Sent:31/03/2020 2:13:48 PMSubject:submission in relation to development at 185 Prince Alfred Parade, Newport -
DA2020/0219

Submission in relation to Development Application DA2020/0219

185 Prince Alfred Parade, Newport

Phot 1: Driveway serving No 187 and 187. My property No 187 is on the left at the top of the driveway.

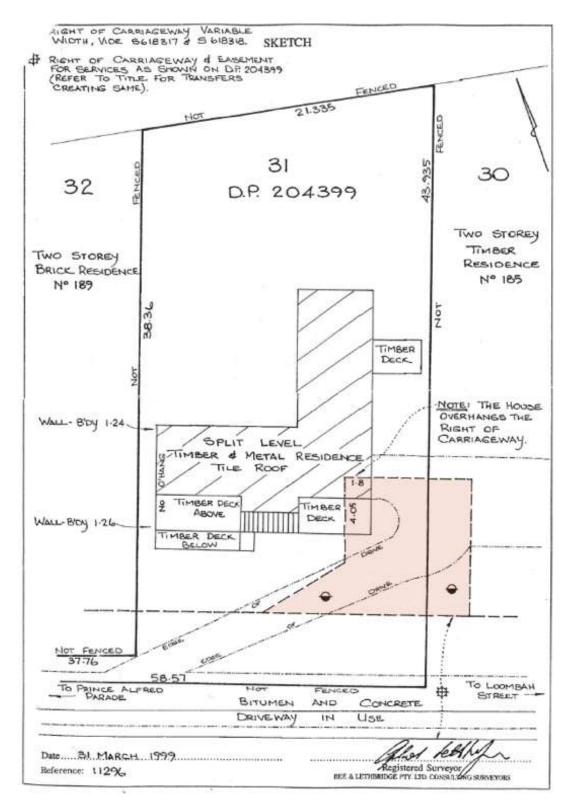
Vehicle access to both my property and No 185 is via a steep driveway across my property. The parking spaces at the top of the driveway are some 7m above the shared roadway below.

A photo of the driveway is shown in **Photo 1** below.

As I have stated the driveway is very steep. Access to parking under my house requires a vehicle turning movement at the top of the drive. If the current circumstances are significantly restricted this could result in an unsafe access.

Without sufficient space at the top of the drive vehicle access to my property becomes dangerous and in wet weather conditions could be impossible, given the steepness of the drive and the tightness of the turn required at the top of the drive. In these circumstances if the vehicle cannot make it into the parking space (eg. as a result of wheels spinning) the vehicle can become stuck.

Figure 1: Right of Carriageway

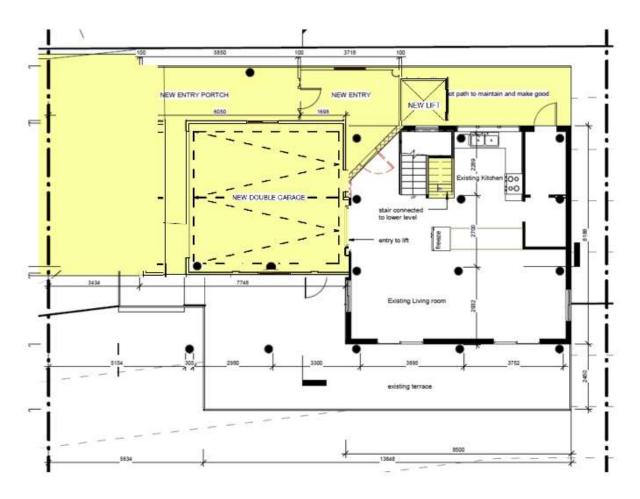
Both properties are subject to a right of carriageway. The right of carriageway is shown below in **Figure 1**.

The right of carriageway shown in **Figure 1** (which was presumably created before both dwellings were constructed) does not reflect the situation on the ground in that it does not align with the physically constructed driveway.

In this regard it is impossible for either myself or No 185 to access/exit, in a car, the vehicle parking at the top of the driveway serving either property without going outside the area of the right of carriageway. For example, the right of carriageway does not cover the full width of the driveway as such it is impossible for No 185 to access their parking with a car without utilising my land outside the right of carriageway. Neither does it provide sufficient area at the top of the driveway for me to manouvre into my car parking space or for 185 to reverse out of theirs. This is a circumstance that has existed for some 35 years or so since my house was constructed.

I am pointing this out not to prevent my neighbour constructing a garage but to highlight that the existence of the right of carriageway, or that the proposed garage does not impinge on the right of carriageway, should not/cannot be used to justify a development that has a significant adverse impact on my ability to safely and conveniently access my property. There has been mutual acceptance over the years between the owners/occupiers of both properties that whilst the right of carriageway does not properly serve the purpose for which it was intended the driveway and space at the top of the driveway should be used to facilitate safe and convenient access. This circumstance should be maintained.

Figure 2: Option for redesign

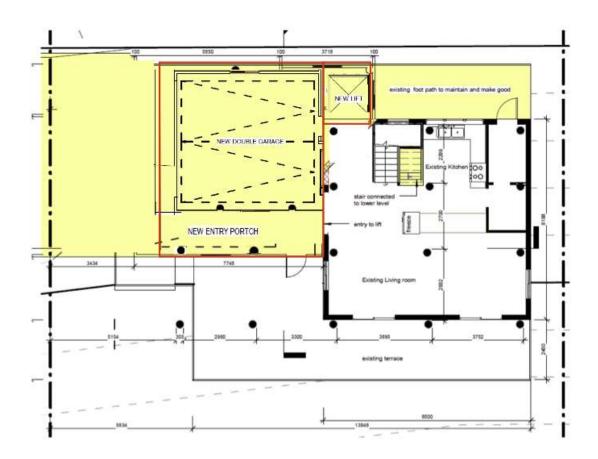
I have provided two redesign options in **Figures 2 and 3** below that will facilitate the provision of a safe and convenient access for both properties. These involve the relocation of the proposed lift, which is currently proposed to be located between the existing dwelling and the proposed garage, to the rear of the existing dwelling adjacent to the existing stair. This will allow the proposed garage to be set back further.

I consider that these options are reasonable and should be given serious consideration. They will allow for a safe and convenient access to my premises albeit still restricted in comparison with that which currently exists.

The further away from the boundary that the garage is located the safer the access becomes. I believe that a garage can be provided whilst maintaining sufficient space to provide a safe and convenient access to my premises (a key outcome of the relevant DCP provisions), albeit one that is still compromised in comparison with the existing circumstances.
